Service Bulletin

NUMBER _ 2932-20001

BUNK COVERS

MOTOR HOMES SERIAL 00646 TO 00800 APPROX.

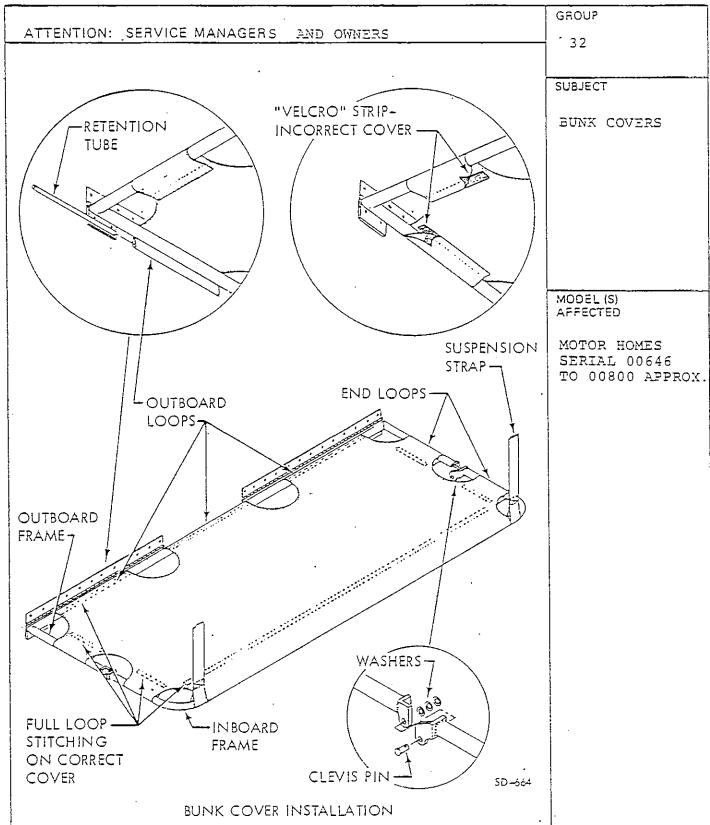
Inspect bunk covers installed on coach to determine if covers need to be changed. You can tell
an incorrect bunk cover by the "Velcro" style
fastener used instead of stitching (See Figure).
The correct bunk cover has full looped stitching.

If you determine that coach has the incorrect cover, remove old cover by breaking loops at each "Velcro" fastener. Discard old cover.

3. Separate frame halves at the hinge point by removing cotter pins, washers, and clevis pins or pins with ball. Retain washers for use on new cover.

- 4. Slip the inboard half of the cover (single loop) over the inboard half of frame along with the suspension straps.
- 5. Slide the end loops (each end of cover) over the ends of the inboard frame working them on part way alternately one end then the other.

6. Move frame and cover inside coach and install clevis pins (M-25225) with three washers under head of each clevis pin. Install the inboard frame and cushion to the outboard frame with the clevis pin heads toward the inner loop of the frame.

7. With the frame in a half-folded position, slide the three outboard loops down between the outboard frame and hinges. Insert retention tubes (5107674) into each loop. Snap the frame assembly into the flat or open position to centralize the cover and pull the retention tubes into a locking position.
